ALBERT B. CHANDLER MEDICAL CENTER UNIVERSITY OF KENTUCKY HOSPITAL EXPANSION & RENOVATION

REVISED MECHANICAL PLANS
HOSPITAL EXPANSION & RENOVATION
A. B. CHANDLER MEDICAL CENTER
PROJECT NO. 304.1
BID PACKAGE #2

M-29

SUPPLEMENTAL DRAWING

Eighth Floor Plan
SC: 1/8" = 1'-0"

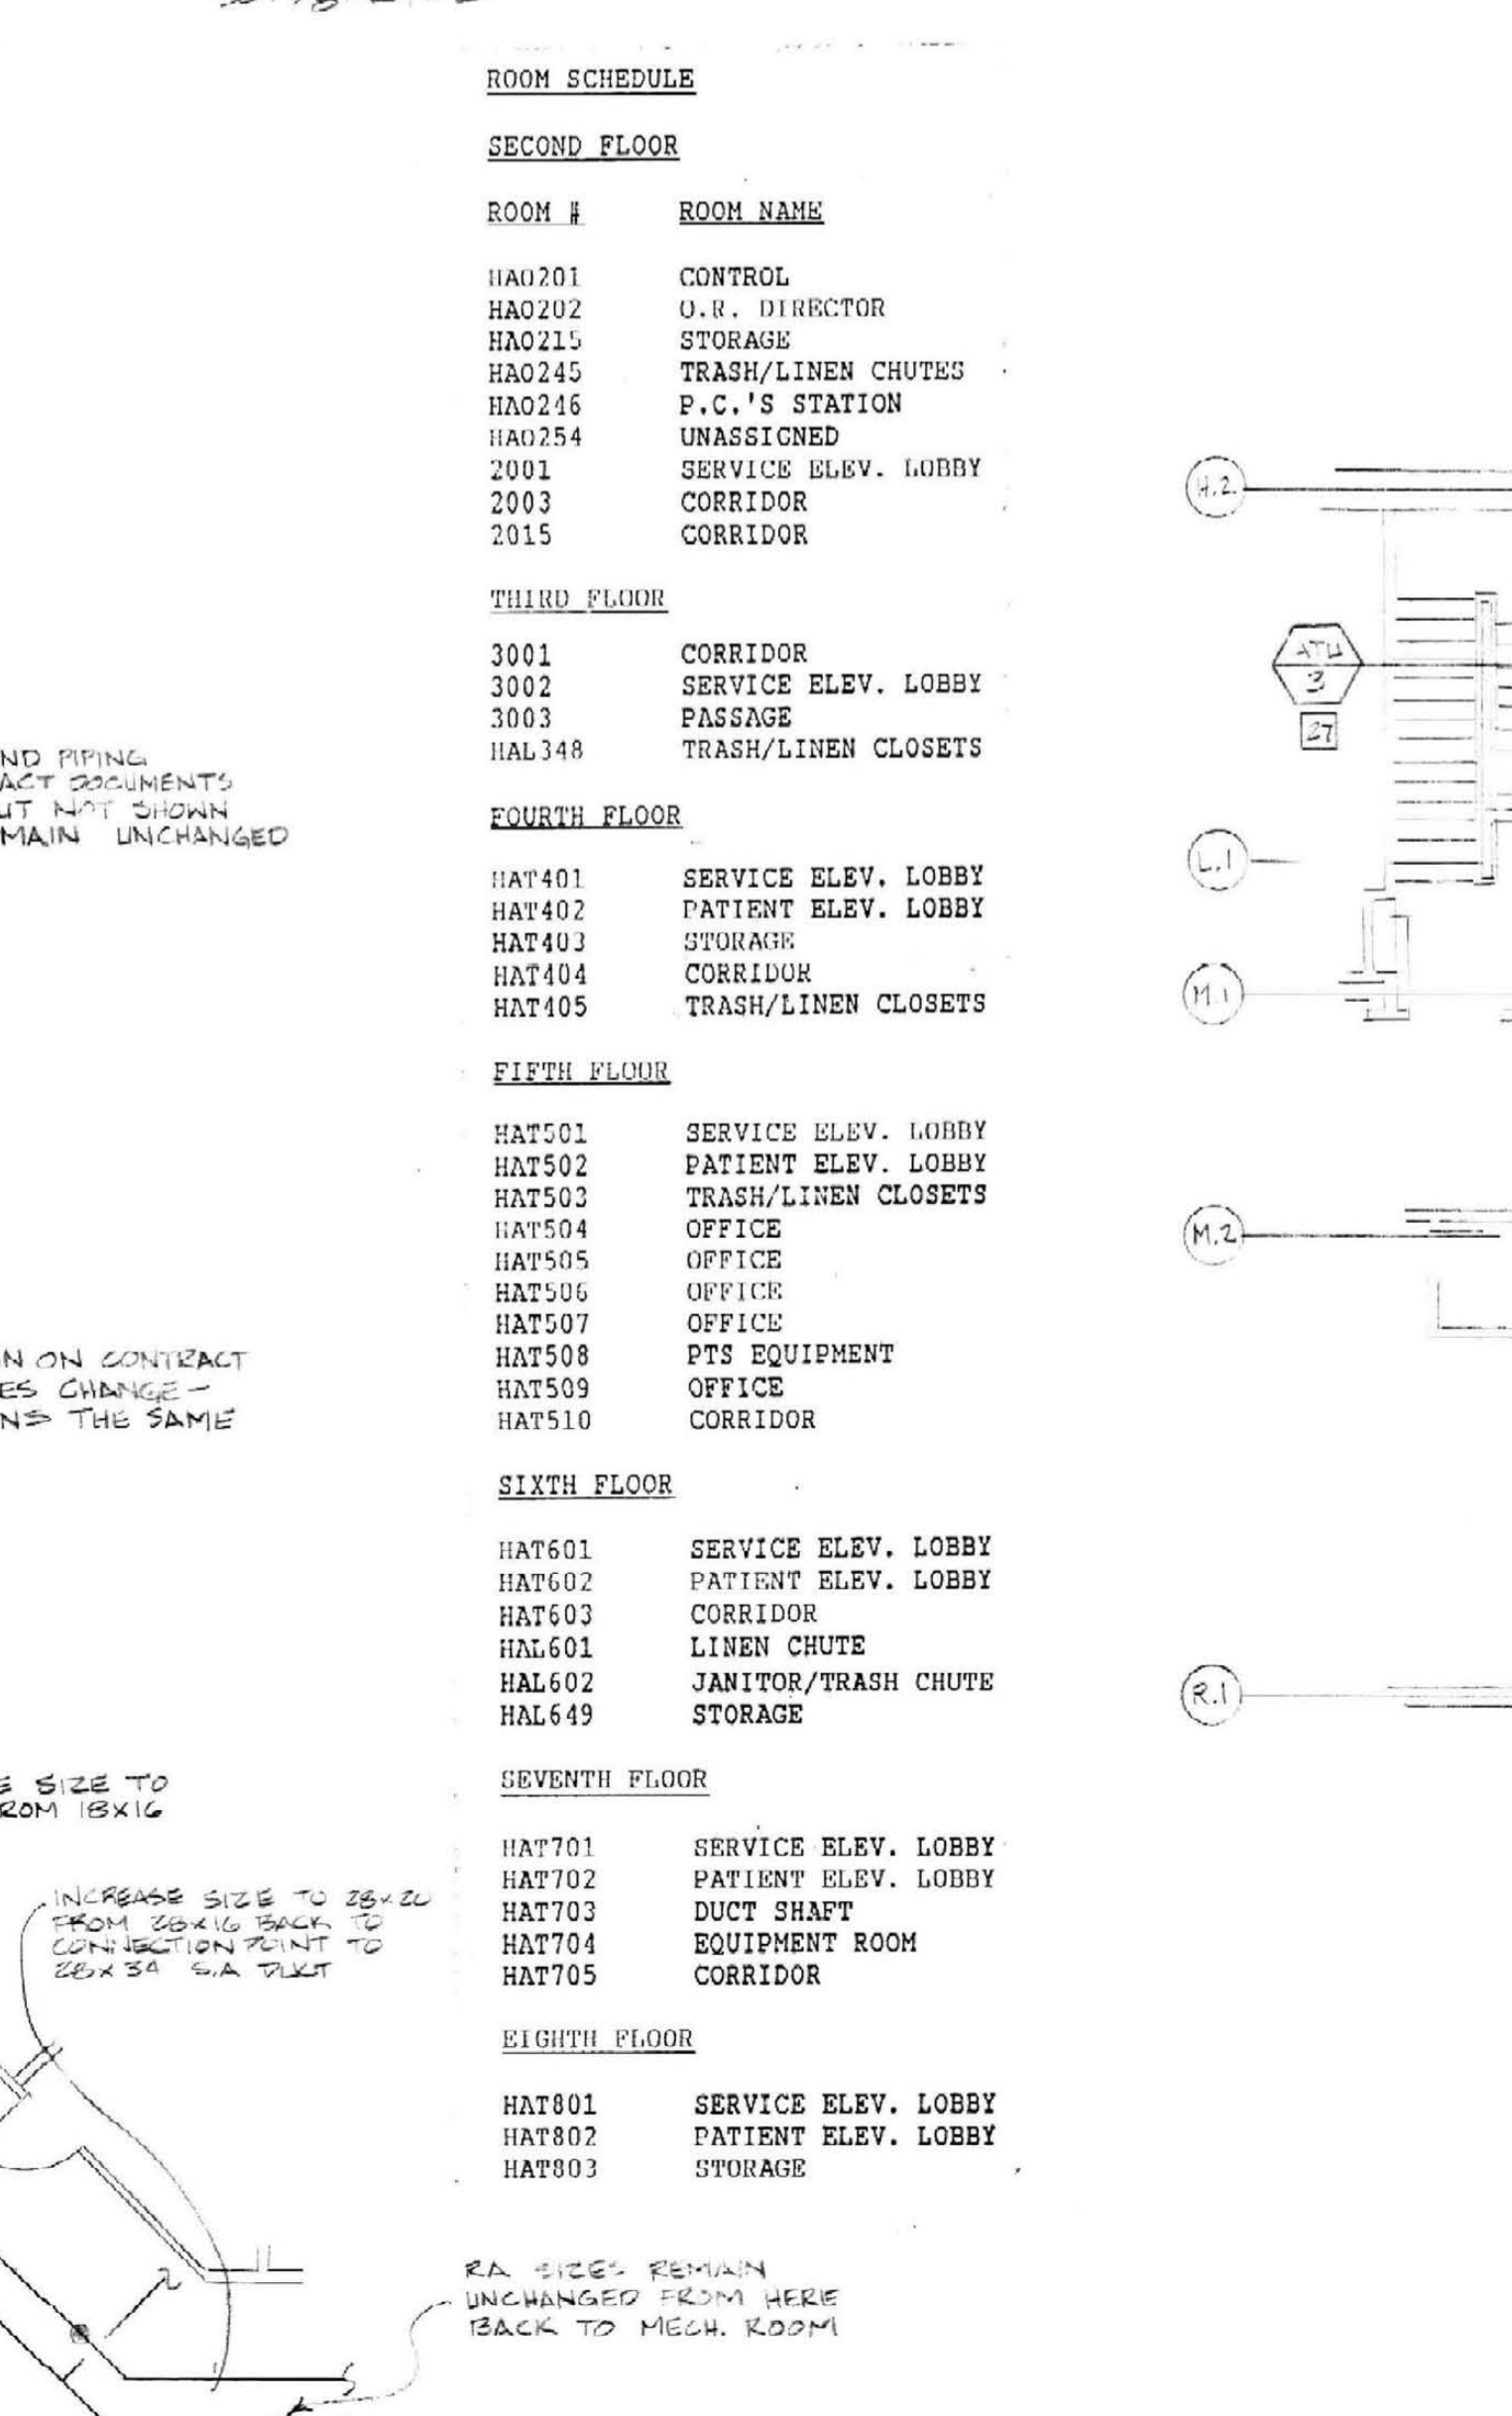
The following hot water coils shall be provided
with 3-way hot water heating valves:
Eighth Floor
Room HAT 801, ATU-3, 1.2 GPM
All other heating coil valves to be 2-way.

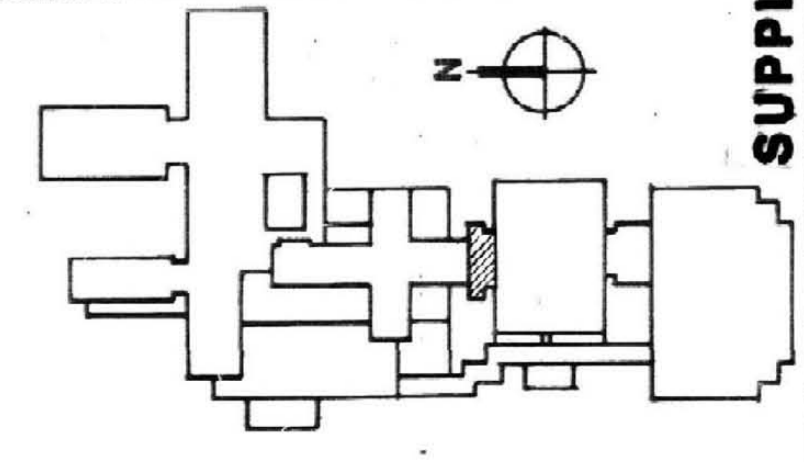
DUCTWORK SHOWN ON CONTRACT
DOCUMENTS, SIZES CHANGE -
LOCATION REMAINS THE SAME

INCREASE SIZE TO
26X16 FROM 18X16

INCREASE SIZE TO
26X22 FROM 18X16
CONNECTION POINT TO
26X18 E.A. DUCT

E.A. SIZES REMAIN
UNCHANGED FROM HERE
BACK TO MECH. ROOM
